**PLANNED UNIT DEVELOPMENT &
SUBDIVISION STAFF REPORT****Date: September 15, 2016****NAME**

Rangeline Crossing Subdivision

CONTEMPLATED USESubdivision Approval to create two legal lots of record, and
Planned Unit Development Approval to allow shared
access between two lots.**TIME SCHEDULE**

SITE PLAN

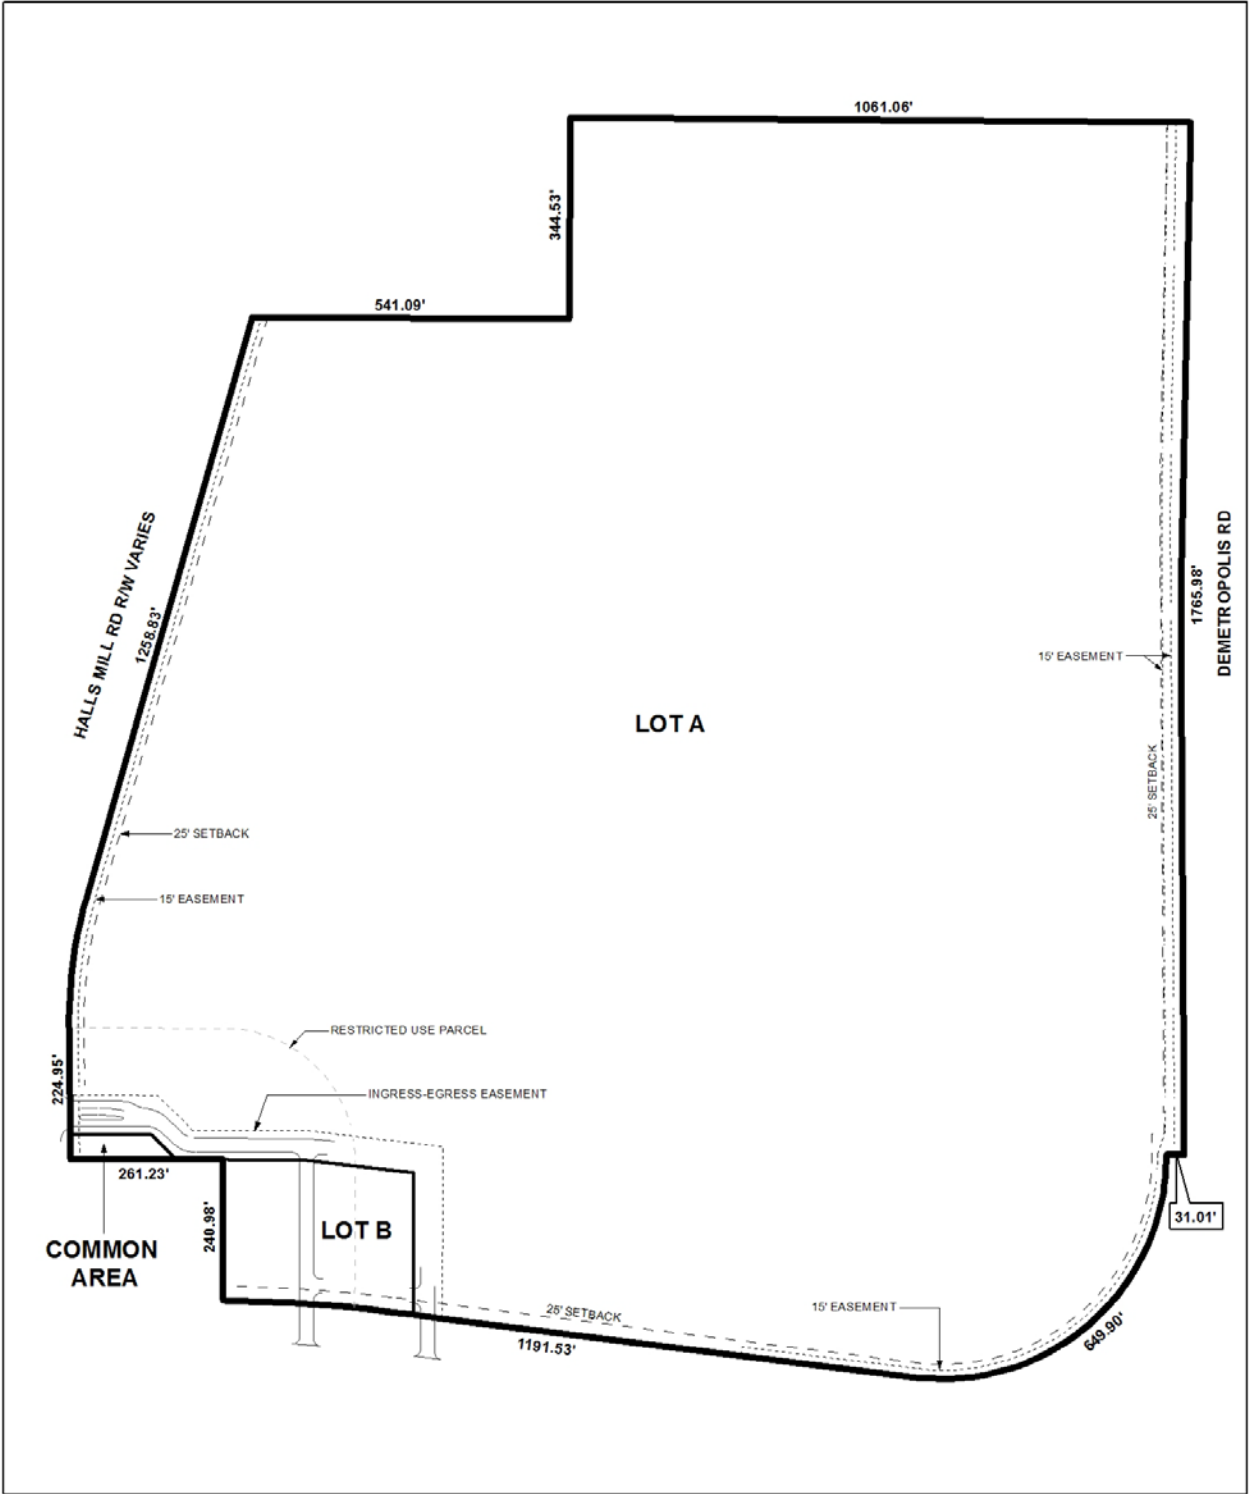
- D. Show and label each and every existing easement. GIS indicates a drainage easement recorded along the rear of LOT B, extending from Halls Mill Rd.

The purpose of the Planned Unit Development is to allow shared access between the two proposed lots via an ingress/egress easement. It should be noted however, that that PUDs are site plan specific, and no improvements are illustrated for either lot. During meetings between the applicant and staff, it was discussed that the currently proposed Lot B is to be developed, with the proposed Lot A to be developed at a later time. With this in mind, the site plan should be revised to illustrate all proposed improvements for Lot B. Without specific improvements illustrated, it is difficult to determine the site’s compliance with the Map for Mobile. Furthermore, new applications will be required for the development of Lot A.

It should be noted that the 25’ setback is shown along Halls Mill Road and Rangeline Service Road, however there is a 35’ and 40’ setback illustrated along Demetropolis Road. If approved, the setback should be retained along all frontages.

It should also be noted that there are water and sewer easements in addition to the ingress/egress easement on the site. If approved, a note should be placed on the Final Plat stating that no structures are allowed in any easements.

There is a common area depicted on the preliminary plat. If approved, a note should be placed on the Final Plat stating that maintenance of the common area is the responsibility of the property owners and not the City of Mobile.

- 1) retention of the 25' minimum building setback line;
- 2) retention of the lot size in square feet and acres;
- 3) placement of a note on the plat stating that Lot A is limited to two curb-cuts per street frontage and Lot B is limited to one curb cut to its street frontage, with size, location and design to be approved by ALDOT (where applicable) and Traffic Engineering and conform to AASHTO standards;

- 1) revision of the site plan to illustrate all improvements for proposed Lot B;
- 2) placement of a note on the site plan that improvements to Lot A will require new Planned Unit Development approvals;
